**VENETA PLANNING COMMISSION'S  
STAFF REPORT**  
**Cheney Drive Apartments - City File #SR-1-23**  
**Site Plan Review**  
**Assessor's Map/ Tax Lot No. 18-06-01-00-01610**

Site Plan Review request for a proposed 128-unit apartment development.

### **FINAL ORDER OF THE VENETA PLANNING COMMISSION**

## CONCEPTUAL LANDSCAPE PLAN

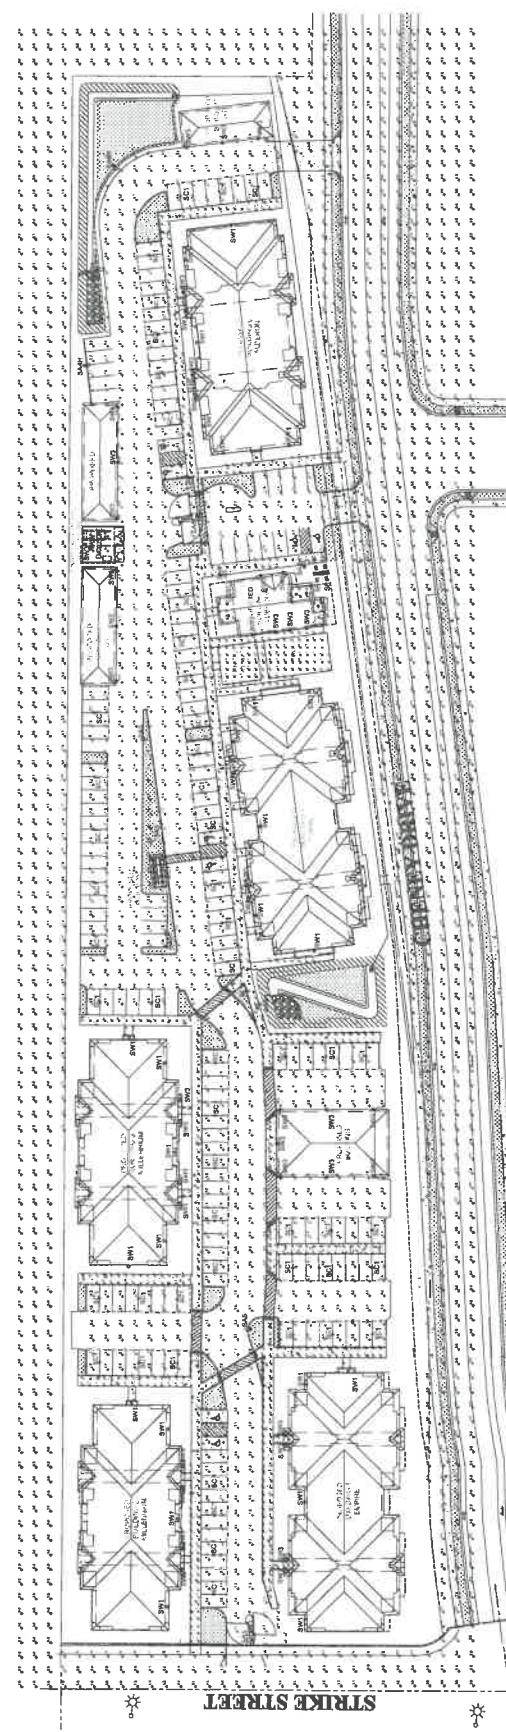
**Staff Finding:** Sheet C-2.0 (**Exhibit B**) indicates the types of shrubs planned for the site but does not list the quantity. Prior to issuance of building permits, applicant shall submit a final landscaping plan that clearly shows four 5-gallon shrubs or accents plants and one tree, a minimum of 2" caliper per 1,000 square feet of landscaped area. This will be a condition of approval.

**Condition of Approval:** Prior to issuance of building permits, applicant shall submit a final landscaping plan that clearly shows four 5-gallon shrubs or accents plants and one tree, a minimum of 2" caliper per 1,000 square feet of landscaped area.

**Exhibit 12-2 Right Turn Lane Criterion**

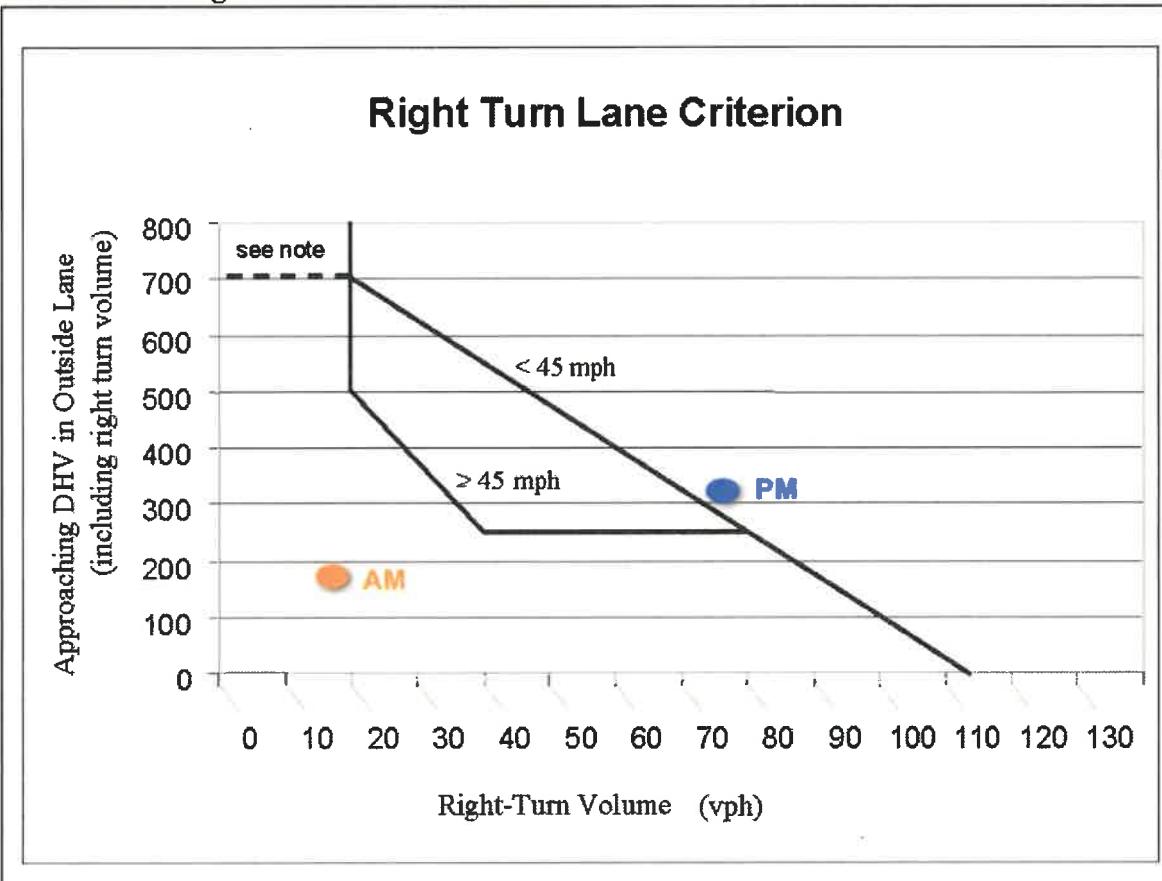
2) Disagreement on the need for a southbound right turn lane on Territorial Highway. The master planning efforts mentioned above also identified the need for a southbound right turn lane on Territorial Highway at the Cheney Drive intersection. This was identified and agreed as being needed during the buildout of this subdivision, approximately by the sixth or seventh phase depending on follow-up traffic analysis during the approval of subsequent phases. The most recent traffic analysis by Sandow Engineering determined that with the Cheney Apartments (Applegate Phase IX) the right-turn lane warrant was met. It is noted that concern was also expressed in the report about the right turn lane potentially being a safety concern for pedestrians attempting to cross Cheney Drive. Lane County believes that the right turn lane is needed for public safety and that pedestrian crossing issues can be addressed by the design details associated with the turn lane. Without the turn lane, Lane County's safety analysis finds an increased risk of rear-end collisions due to high turning volumes projected at this intersection. Based on review of correspondence and comments to date, the applicant's concern is primary based on the difficulty of ROW acquisition for the turn lane and not the safety measures necessary to mitigate the increased risks due to increased traffic from the development of the Applegate Subdivision. The applicant's traffic consultant proposed that one option is to lower traffic speeds on Territorial Highway. Traffic speeds on roadways in Oregon are established by ODOT and are based on speed zone studies of actual speeds. Design modifications of the roadway would be necessary in order to affect actual speeds and potentially the outcome of the speed zone study. This would be a separate process outside the purview of the current land use action and thus not a practical option at this point without modification to the existing roadway design.

**City Response and Finding:** Applicant submitted a TIA and associated memo from Sandow Engineering, dated 12/21/22 and 2/22/23. It states that a southbound right turn pocket was evaluated at the intersection of Territorial Road at Cheney Drive. The Level of Service, v/c, or queuing conditions does not trigger the need for a right turn pocket. A right turn pocket will result in additional bike and pedestrian conflicts, reducing safety for these users while not substantially improving vehicle travel safety. Additionally, the right-of-way needed to construct a right turn pocket and manage stormwater is not available and cannot be obtained. Therefore,
